ARCOS BULLETIN 2015-1

SUBJECT: IT Design

### IT Design and Construction Criteria Updates

Last Updated: 9 March 2015

A1 TYPICAL TR IT RACKS COMPONENTS FRONT AND REAR VIEW

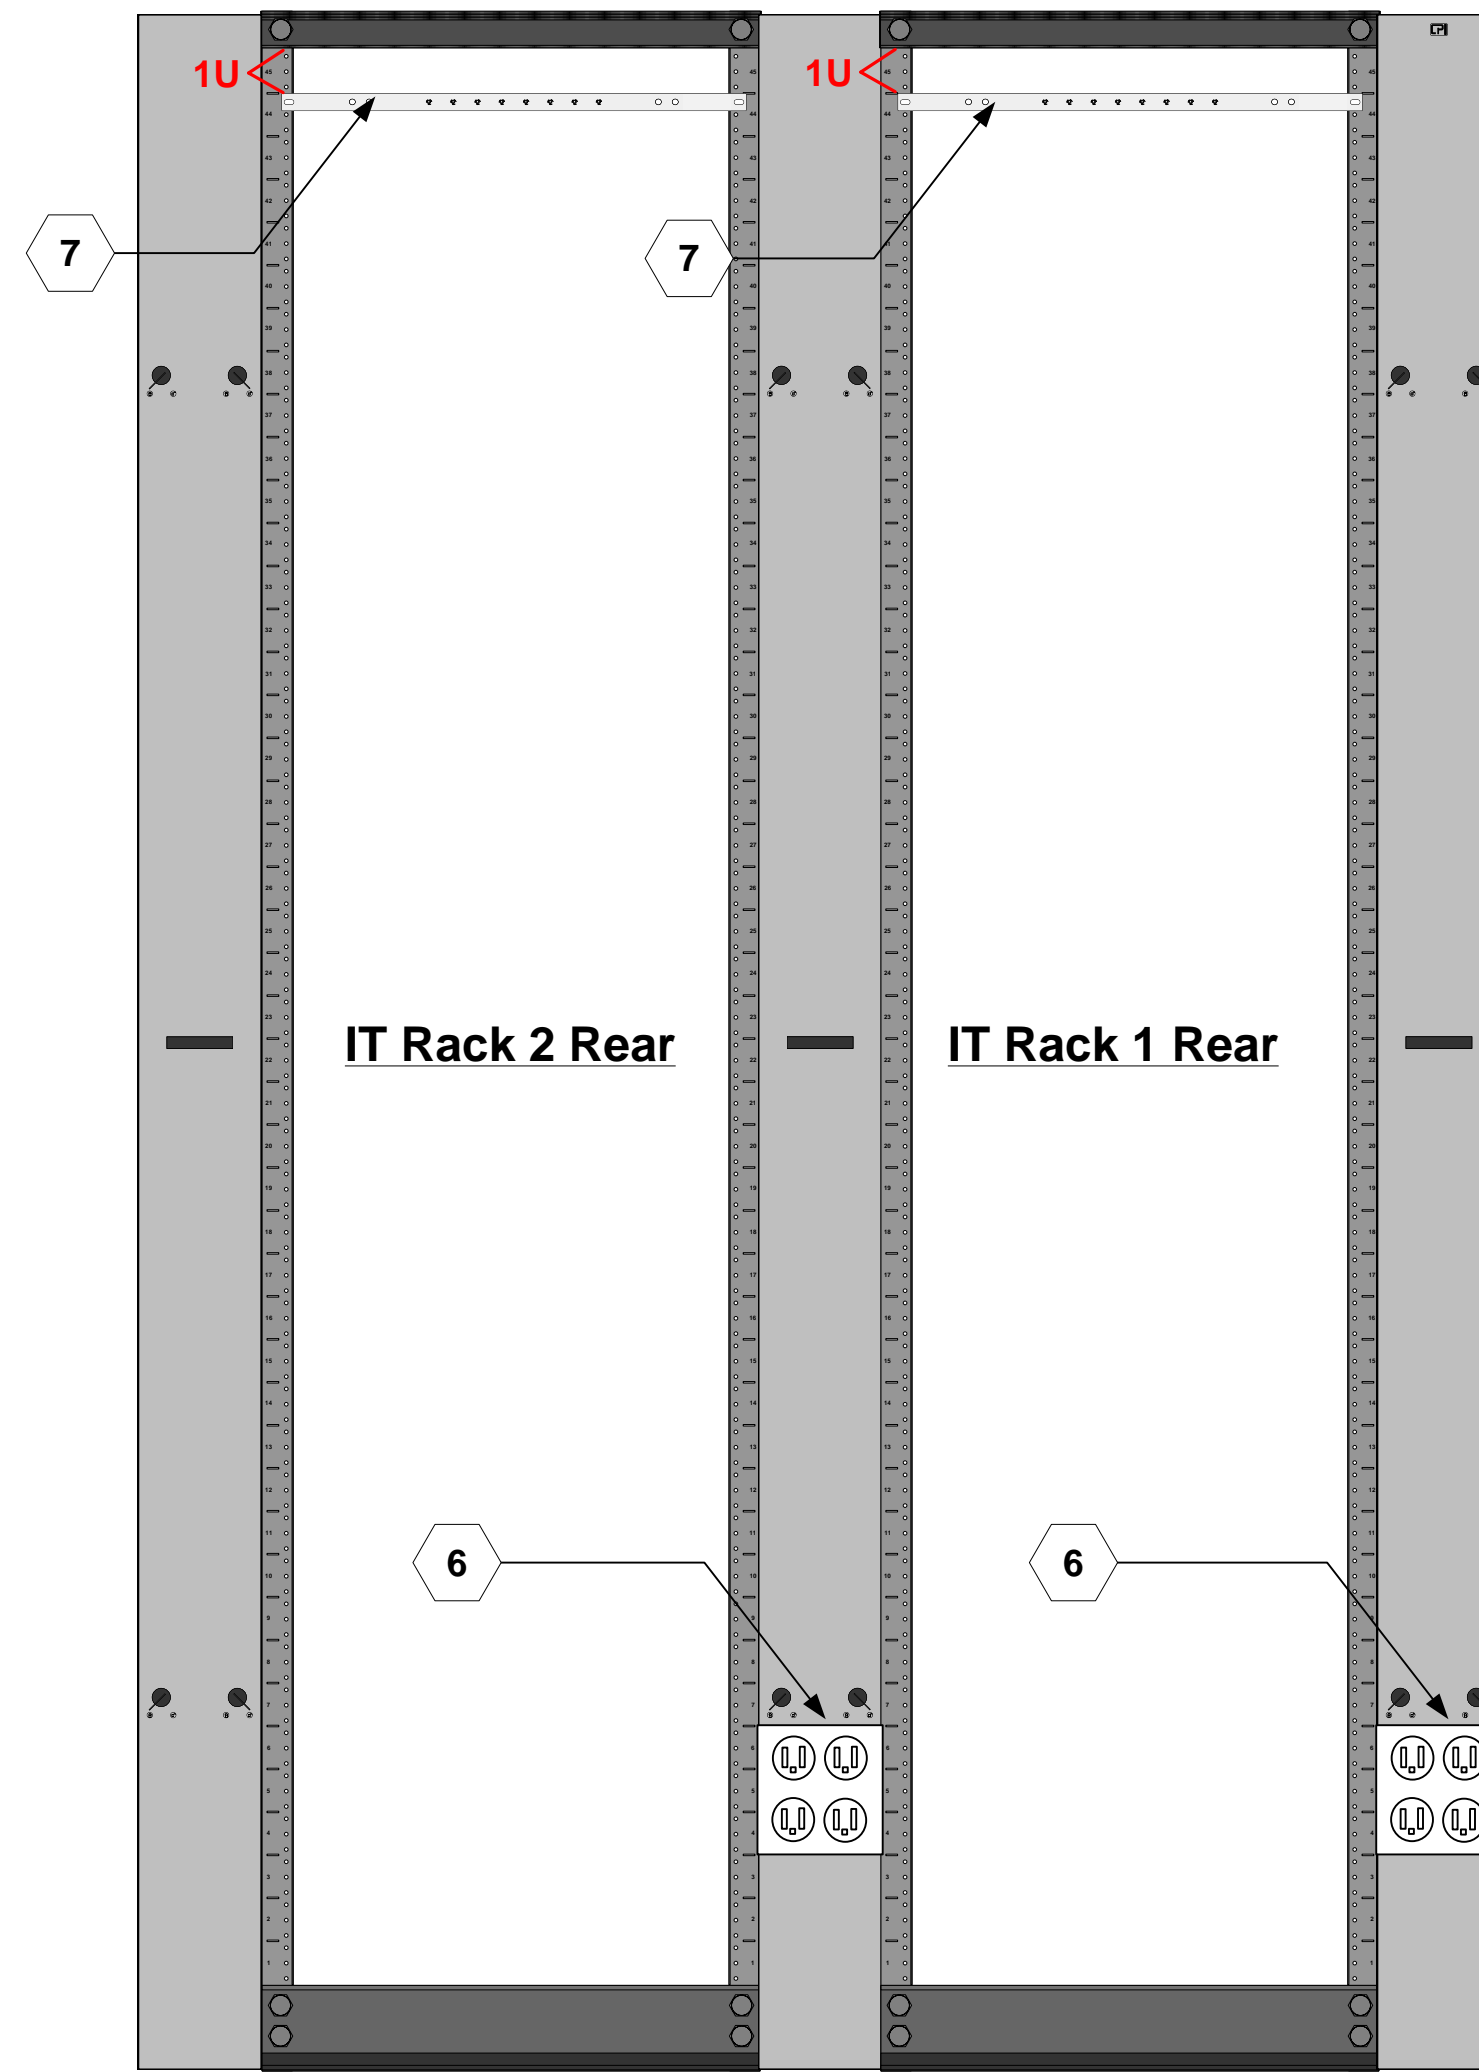
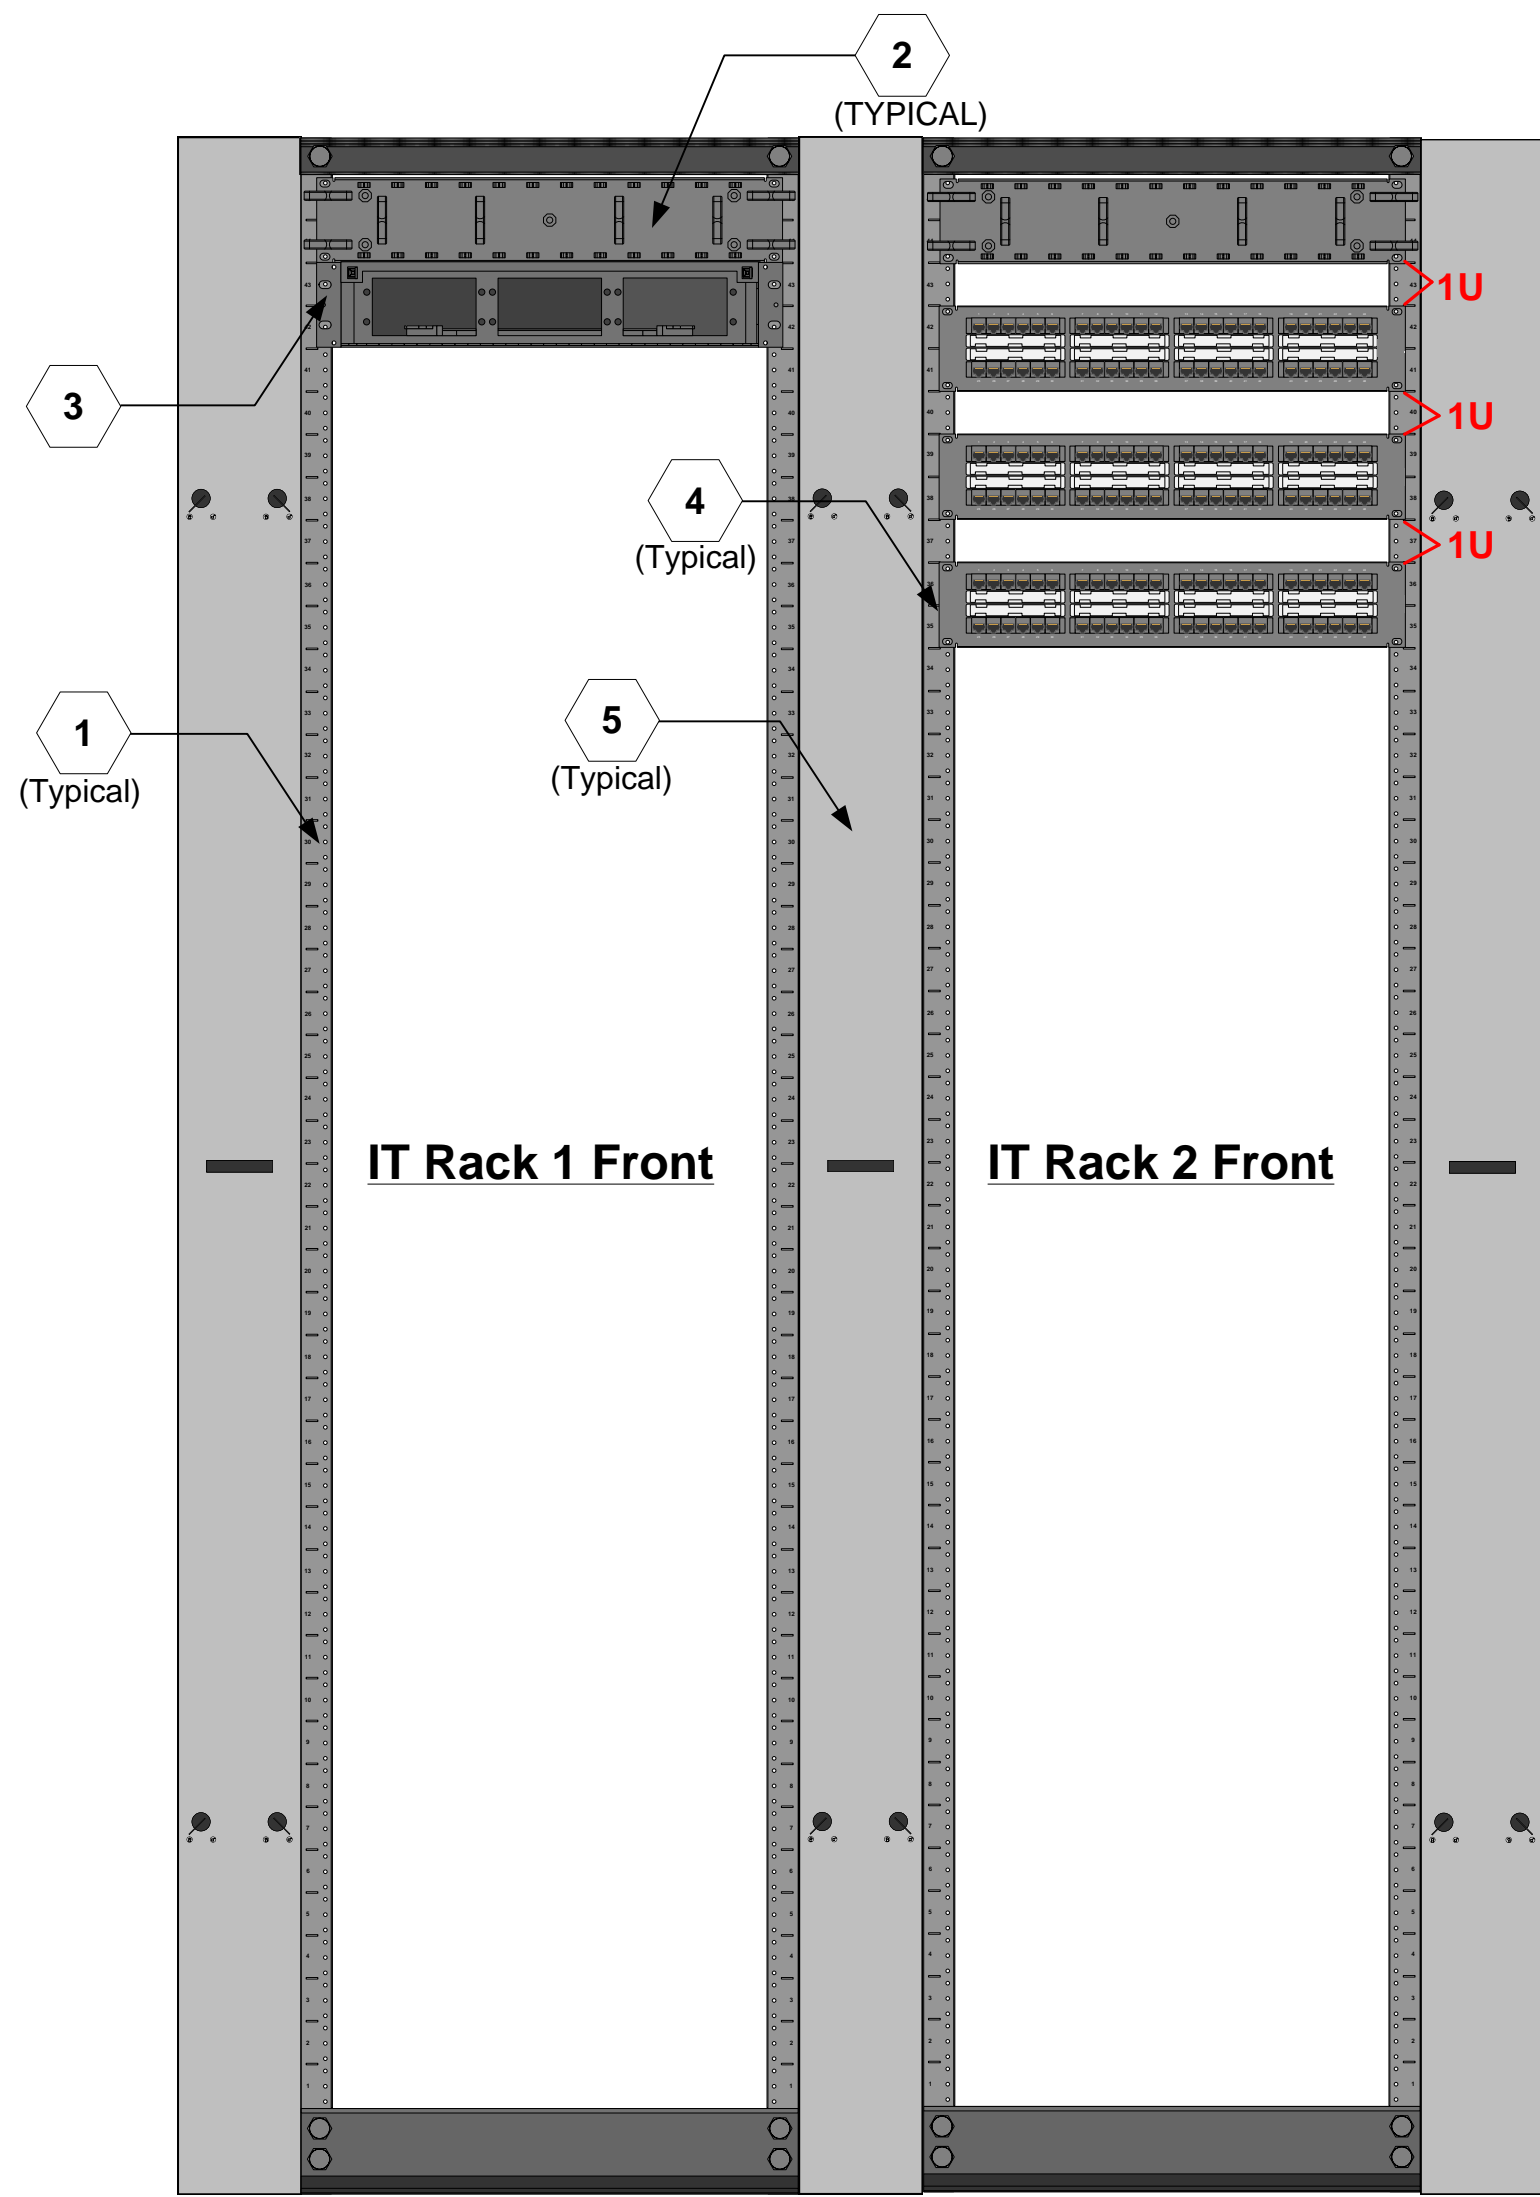
- 4.1.4. All horizontal category 6 cabling will now be terminated IAW the T568B pin-out.
- 4.1.5. The top and bottom 2U horizontal wire manager in all IT racks are no longer required. See Section 5 Diagrams for further clarification
